# Service Bulletin No. 1068A

<b>COACH MODEL</b>	: T900, T2100 and C2000 Series
<b>BULLETIN TYPE</b>	: Product Improvement
<b>MANUAL &amp; SECTION</b>	: Maintenance Manual: Chapter 9 - Electrical system Spare Parts Manual: Section 782009 - Electrical equipment
<b>PARTS BOOK REVISION</b>	: Yes
<b>DATE</b>	: October 31st, 2001
<b>SUBJECT</b>	: <b>Turn signal/hazard warning flasher change</b>
<b>TERMS &amp; CONDITIONS</b>	: Parts and labor allowance will be provided as per warranty information in this Bulletin.

## THIS BULLETIN SUPERSEDES SERVICE BULLETIN 1068

**Figure 1: Turn signal/hazard warning flashers**

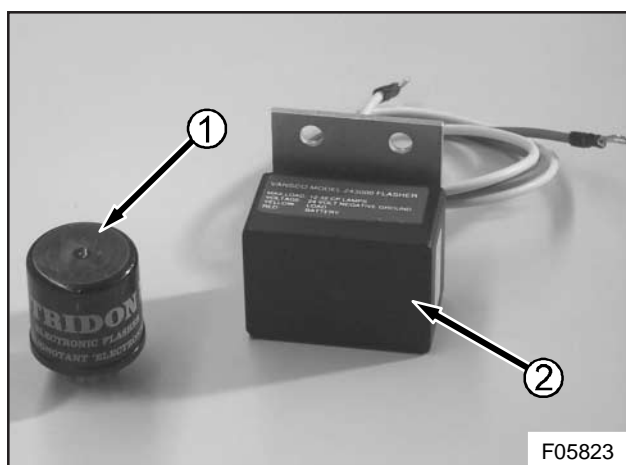
Turn signal/hazard warning flasher operation has been improved in production on T2100 and C2045 coaches by replacing Tridon flasher VH 660762656 with Vansco electronic device

VH10760325. Due to its larger size, the new flasher has been relocated from the old position on the relay rack to the bottom of the Basic Electrics switchboard, both in the front junction box. The change provides for a higher load capacity, constant flasher frequency, solid state technology and a longer service life.

- Old and new parts are not directly interchangeable.
- Only new parts will be offered as service replacements for this application.

- 1. Tridon VH 660762656 (old)**
- 2. Vansco VH 10760325 (new)**

**Figure 2: Location of old flasher unit (T2100 and C2045)**

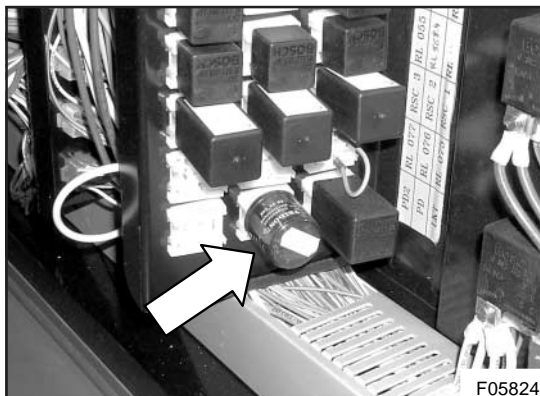
- 1) Open the main junction box and locate the Tridon flasher unit on the relay rack (*T2100 and C2045* : bottom row, middle relay holder, label PD – see Figure 2. *T900* : third row from the top, first relay holder - see Figure 3).

- 2) Withdraw and discard the flasher unit.
- 3) *T2100 and C2045*: Using cutter pliers, cut off the blue-violet and violet-blue automotive wires at the back of the relay holder, right behind the flat blade connectors.

- 1) *T2100 and C2045*: Using the machine screws from the kit, attach the Vansco flasher unit to the basic electrics switchboard as close as possible to the bottom row of the relay rack.

**Figure 3: Location of old flasher unit on T900 coaches**

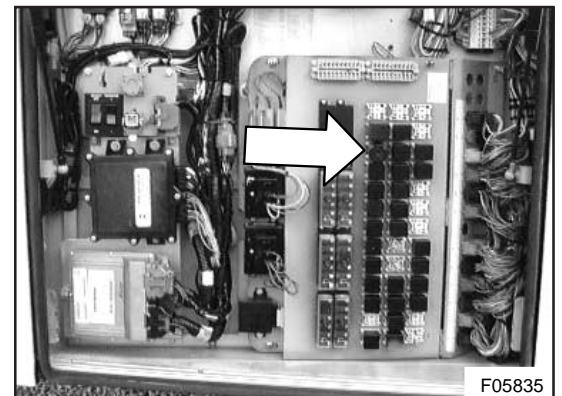
*T900*: Undo and remove the two wingnuts securing the relay and circuit breaker panel to the back of the junction box. Swing out the panel. Using cutter pliers, cut off the red-black and violet-yellow automotive wires at the back of the relay holder, right behind the flat blade connectors.

*T900*: Using the machine screws from the kit, attach the Vansco flasher unit to the relay and circuit breaker panel as close as possible to the old position of the Tridon flasher.

**Figure 4: Vansco turn signal/hazard warning flasher hook-up**

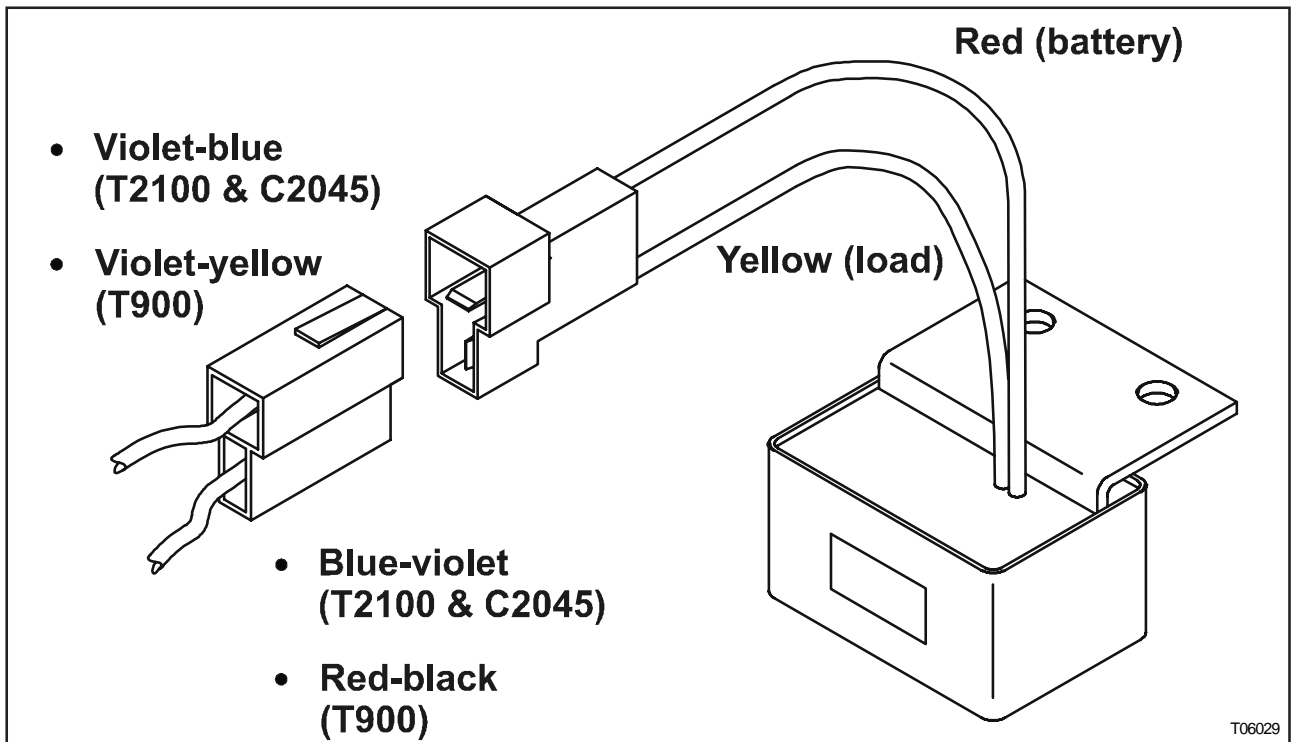
- 2) Cut-off the pre-assembled ring terminals from the Vansco leads and strip back the wires to accept the male flat blade connectors.
- 3) Install the plugs and flat blade connectors as shown in Figure 4:

*T2100 and C2045*: male connectors to Vansco leads, female connectors to blue-violet and violet-blue wires (see chart below).

*T900*: male connectors to Vansco leads, female connectors to red-black and violet-yellow wires (see chart below).

Wire color	Plug	Connector	Connector	Plug	Wire color	To
Blue-violet	VH660768403	VH660765190	VH660766313	VH660768404	Yellow	Load
Violet-blue	VH660768403	VH660765190	VH660766313	VH660768404	Red	Batt.

Wire color	Plug	Connector	Connector	Plug	Wire color	To
Red-black	VH660768403	VH660765190	VH660766313	VH660768404	Yellow	Load
Violet-yellow	VH660768403	VH660765190	VH660766313	VH660768404	Red	Batt.

- 4) *T2100 and C2045*: Route the wires from the Vansco flasher to the back of the flasher box holder through the cable duct at the bottom of the main junction box.

*T900*: Route the wires from the Vansco flasher to the back of the flasher box holder on the relay and circuit breaker panel.
